19 September 2019

Our Ref: N-18047

RE: NIHON UNIVERSITY NEWCASTLE CAMPUS (SSD-9787) - RESPONSE TO INFORMATION REQUEST AND SUBMISSIONS

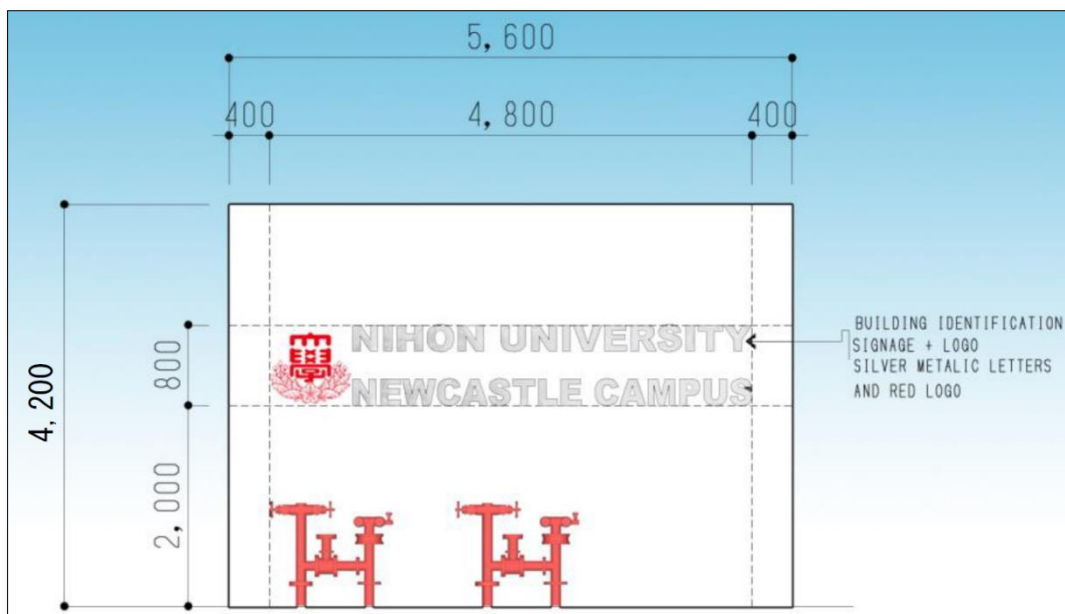
<u>Contributions</u> Clarification is sought as to whether the Section 94A Estimate was calculated in accordance with Clause 25J of the Regulation.	We can confirm that the Section 94A Estimate was calculated in accordance with Clause 25J of the Regulation.
<u>SEPP 64</u> Need to address the requirements of this SEPP.	Refer to Section 4.1 of this letter below.
<u>Waste Management</u> The waste calculation method should be revisited in line with the EPA's publication <i>Better Practice guide for Resource Recovery in Residential Developments</i>.	Refer to the 'Waste Management Response' Memorandum prepared by dwp, dated 11 July 2019 (see Attachment A), which provides revised operational waste calculations and outlines amendments to the design of the waste storage rooms. The Memorandum also explains why bulky goods storage areas are not required for the proposal, and provides details relating to organic green/garden waste management and private waste contractors.

One identification sign is proposed as detailed in the Architectural Plans at Appendix 2 to the EIS. The proposed sign comprises a red logo and silver metallic letters fixed to a new wall fronting Church Street, in front of the new Residential Building. The wall is required to be constructed adjacent to the main site service point beside the driveway entrance for service and delivery vehicles. The wall is a service code requirement

and is designed to the minimum acceptable size. The wall will be finished in tiles to match the new building and the signage.

As shown in the extracted images below, the wall located in front of the east wing will be approximately 4.2m high and 5.6m wide, while the signage will be approximately 0.8m high and 4.8m wide.
